RAMP REPORT REGION 2 ADA 2026

Hills to Sea Trailhead,  
Unity

CR12756

CR12761

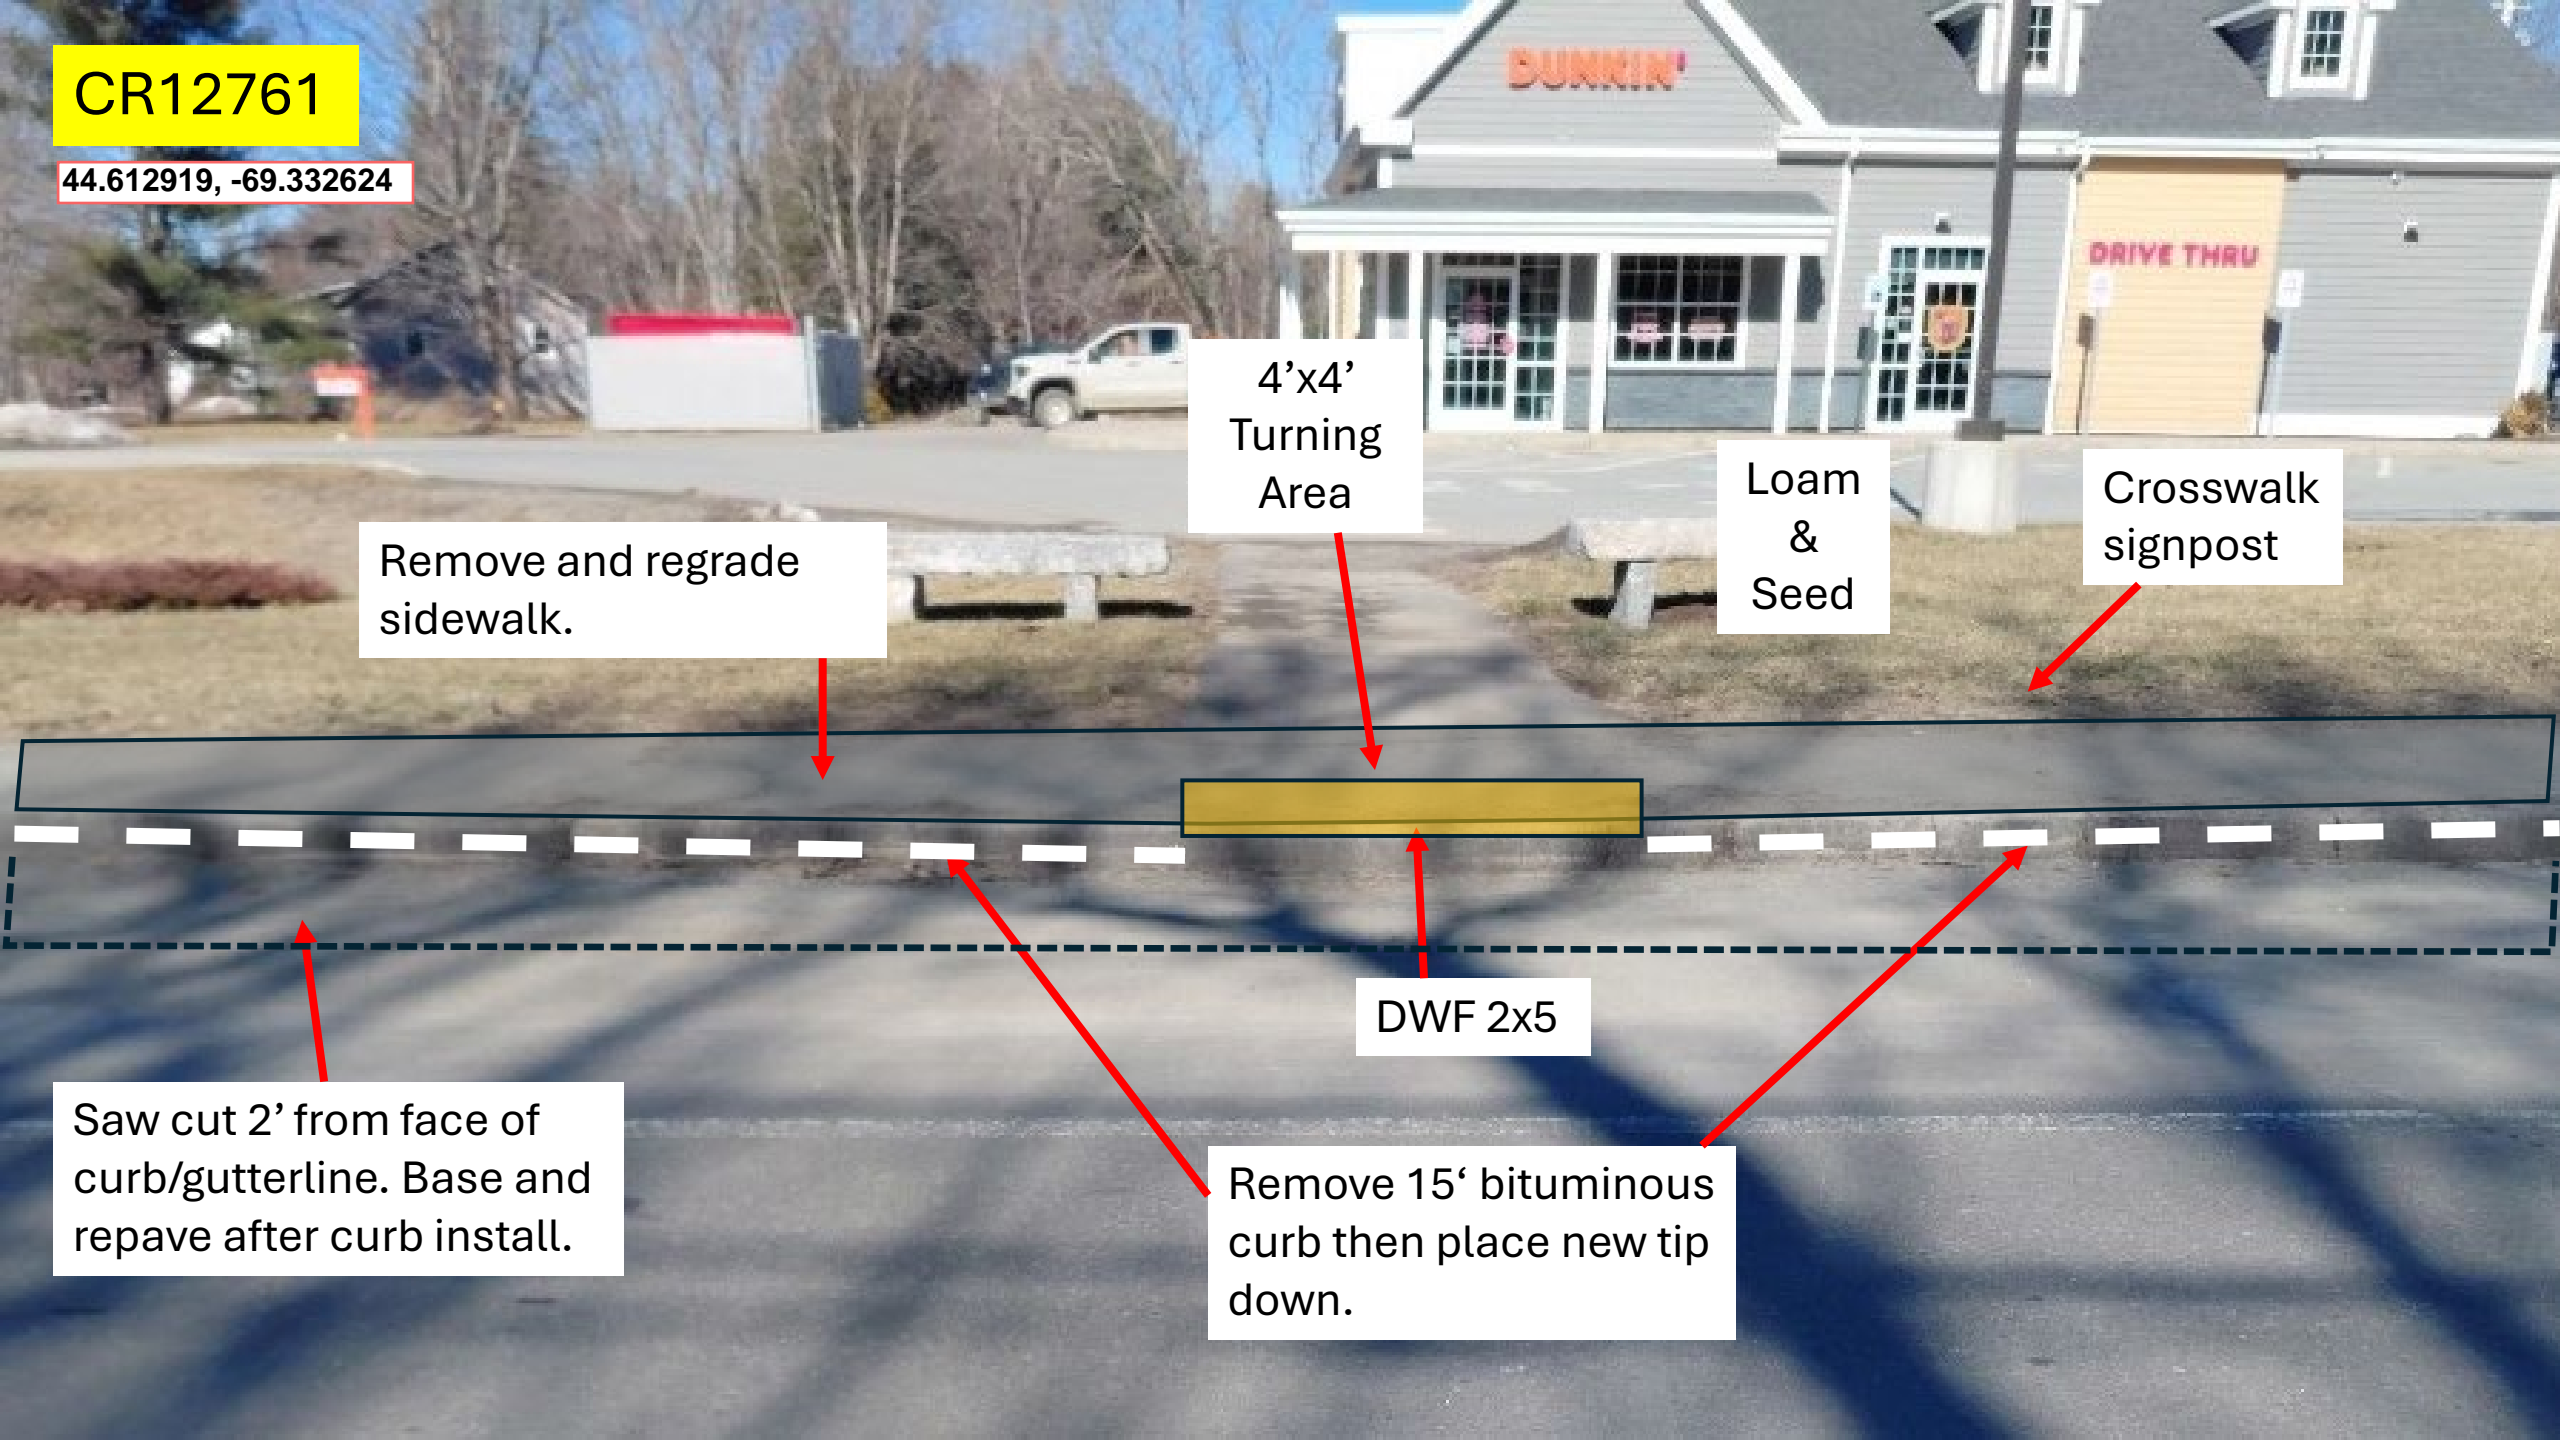
Remove and regrade sidewalk.

4'x4'  
Turning  
Area

Loam  
&  
Seed

Crosswalk  
signpost

DWF 2x5

Saw cut 2' from face of  
curb/gutterline. Base and  
repave after curb install.

Remove 15' bituminous  
curb then place new tip  
down.

Remove and regrade sidewalk.

Loam and seed.

4'x4'  
Turning Area

Crosswalk signpost

DWF 2x5

Saw cut 2' from face of curb/gutterline. Base and repave after curb install.

Remove 15' bituminous curb then place new tip down.

CR12764

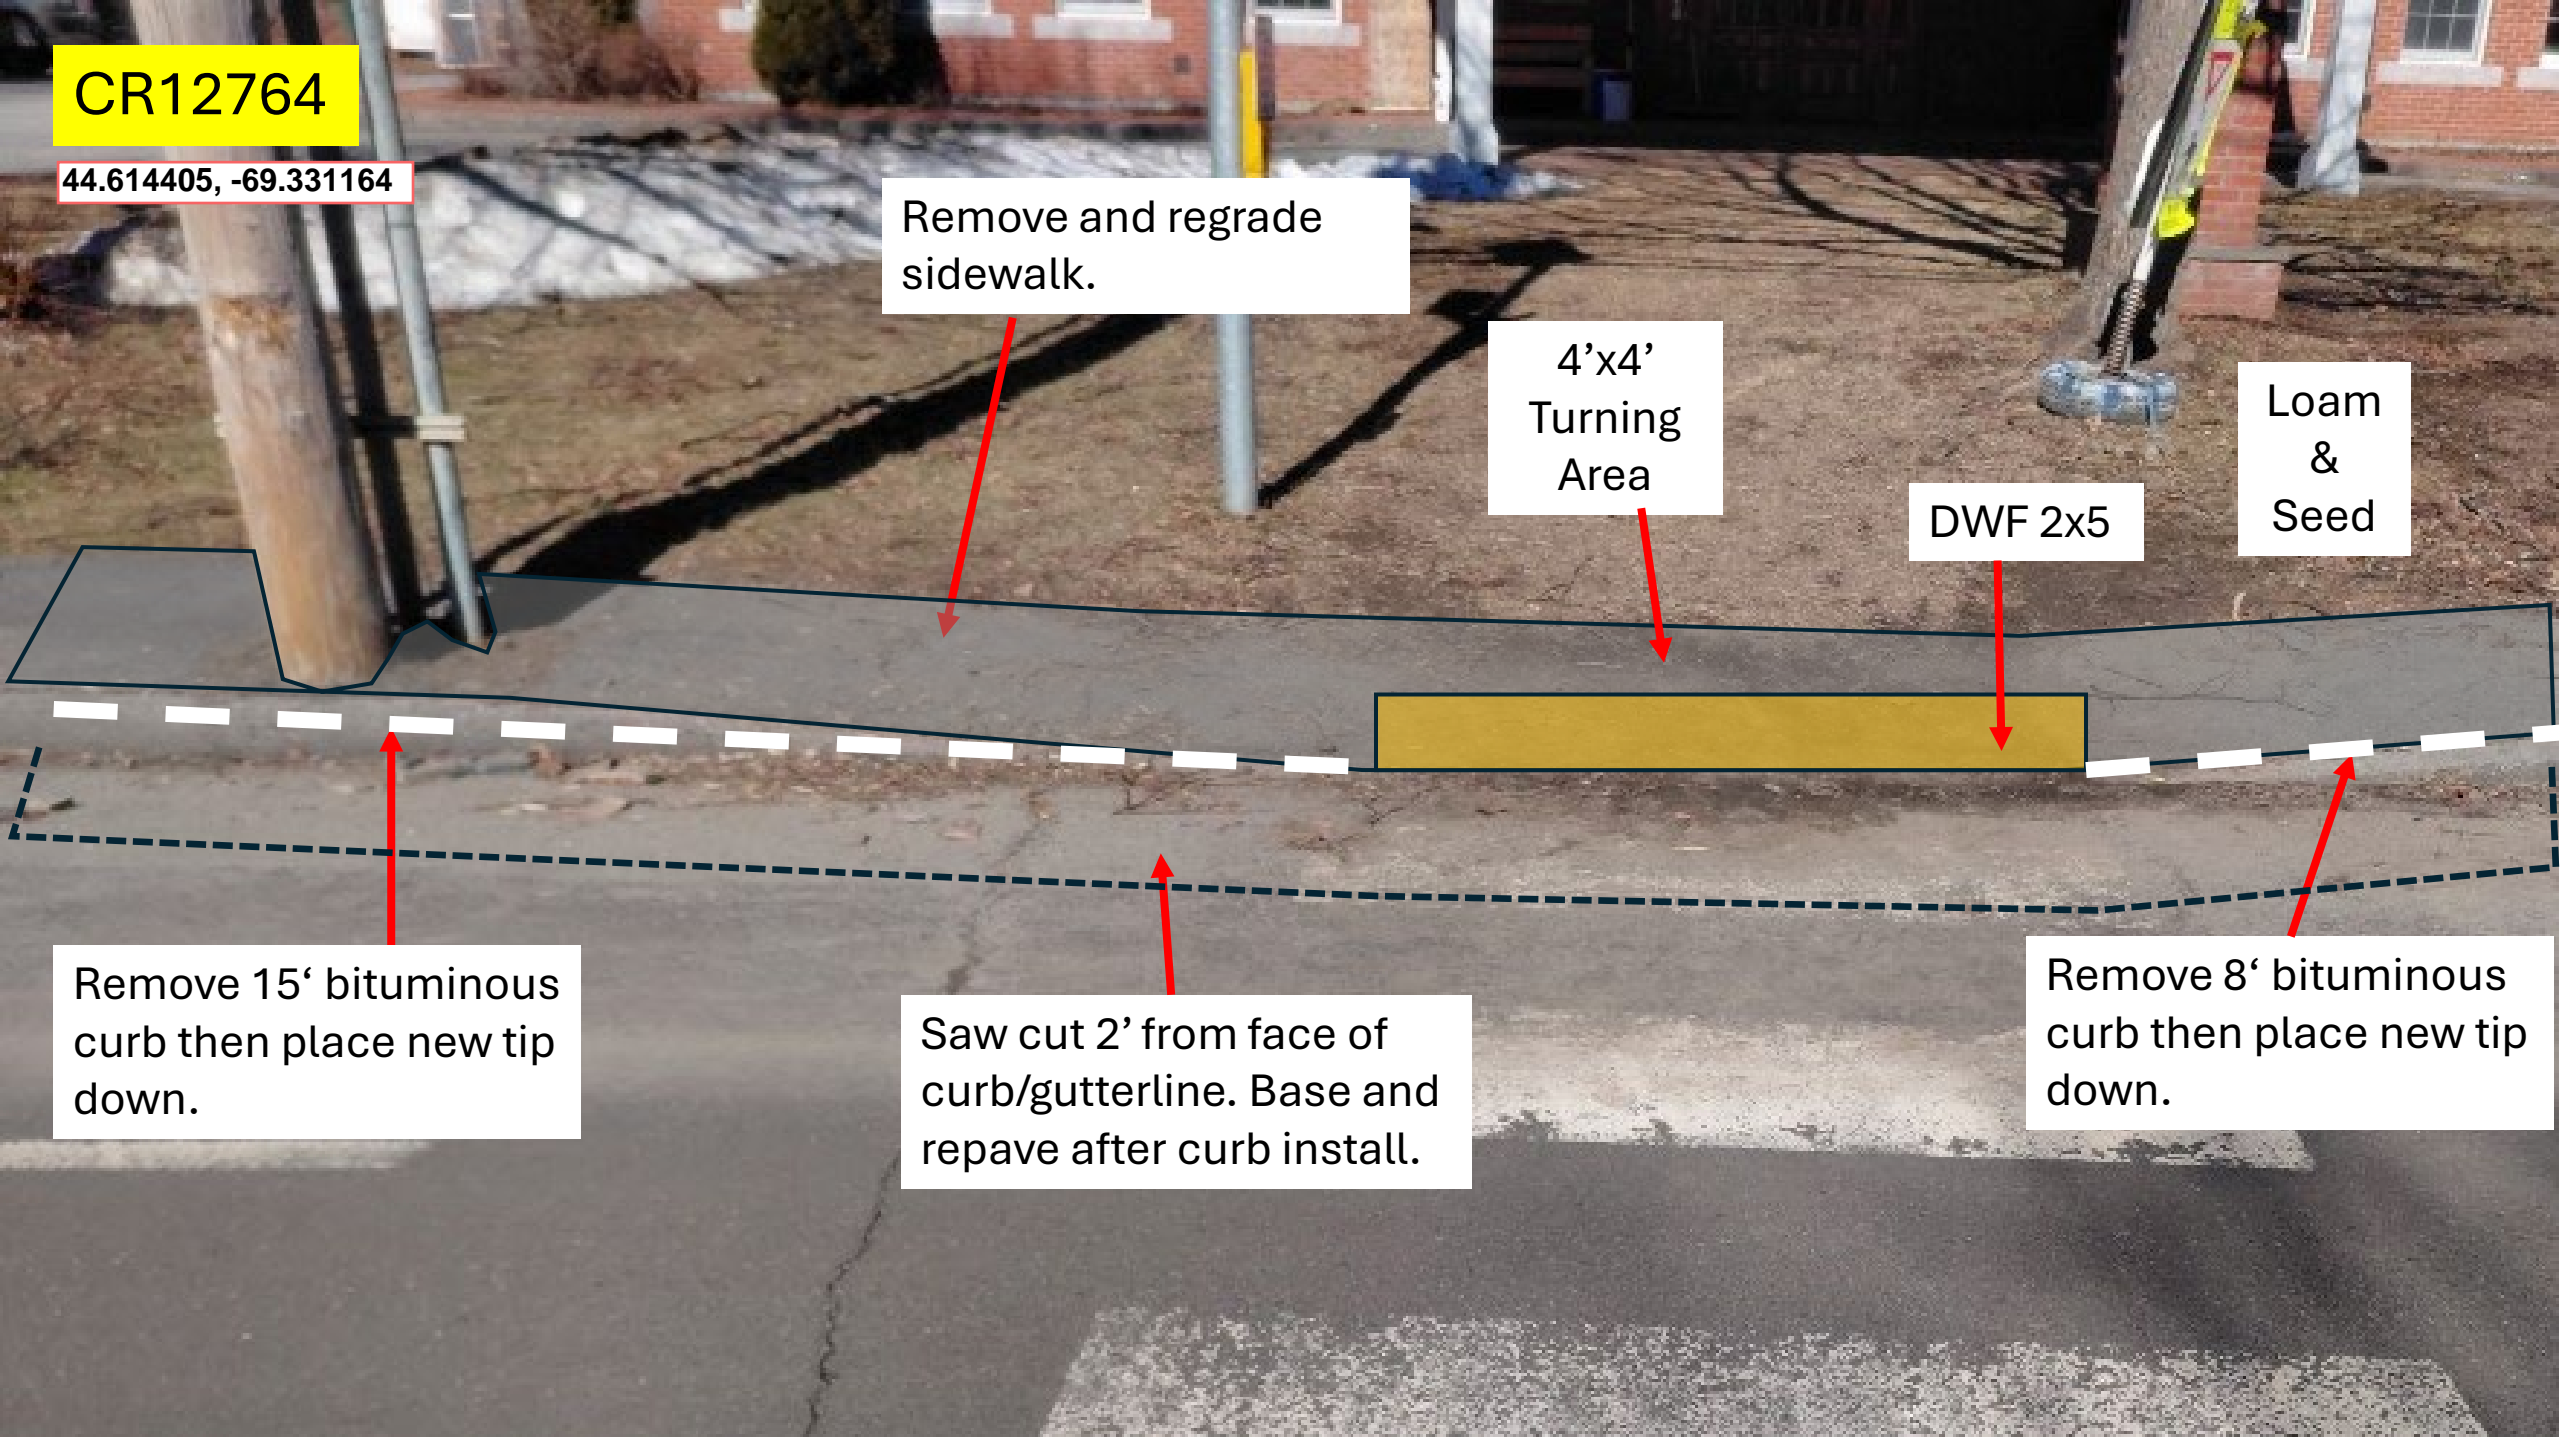
Remove and regrade sidewalk.

4'x4'  
Turning  
Area

DWF 2x5

Loam  
&  
Seed

Remove 15' bituminous  
curb then place new tip  
down.

Saw cut 2' from face of  
curb/gutterline. Base and  
repave after curb install.

Remove 8' bituminous  
curb then place new tip  
down.

CR12765

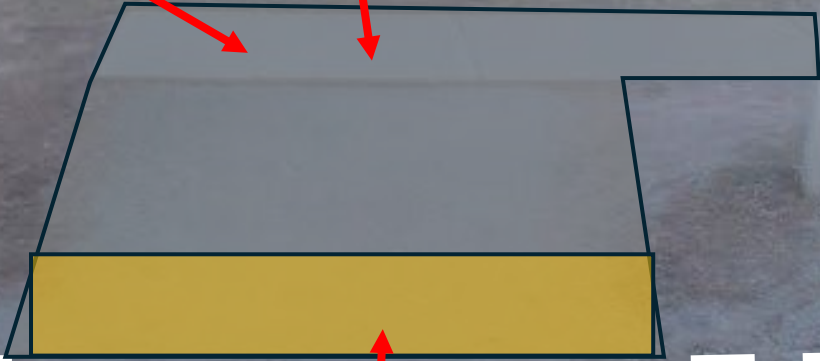
Remove and regrade sidewalk.

4'x4'  
Turning  
Area

The design may need to be revised to ensure the pedestrian push button is located on a level landing that meets ADA/PROWAG accessibility requirements. The landing should provide a stable, and firm, surface with appropriate cross slope and running slope to allow safe and independent use by wheelchair users.

Loam  
and  
seed.

DWF 2x6

Remove 8' bituminous  
curb then place new tip  
down.

Saw cut 2' from face of  
curb/gutterline. Base and  
repave after curb install.
